AMENDMENTS TO THE DRAWINGS

REMARKS

Jong-Joo LEE and Dong-Ho LEE
MULTI-CHIP BALL GRID ARRAY PACKAGE
Attorney Docket No. 9903-080/Application No. 10/828,792

FIG. 2

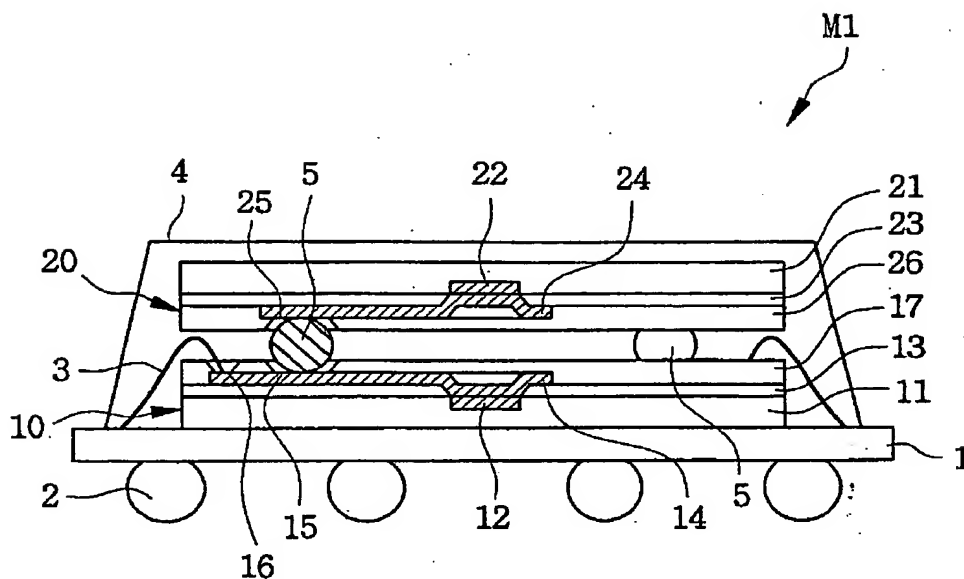
FIG. 2 is amended to include reference number 60 identifying the capacitor provided by the first and second electrode plates 37 and 46. An annotated sheet showing changes and replacement sheet are included in the Appendix following page 11 of this paper.

In a telephonic interview between the Applicant and the Examiner, conducted on August 31, 2005, the Examiner clarified that rejection was due to the capacitor not being specifically identified within any of the drawings. In response to the Applicant's question on how to overcome this rejection, the Examiner agreed that a separate reference number could be added to FIG. 2 to identify the capacitor formed by electrodes 37 and 46. FIG. 2 is amended to identify the capacitor as reference number 60 and a replacement sheet with the amended figure is included and can be found in the Appendix following page 11.
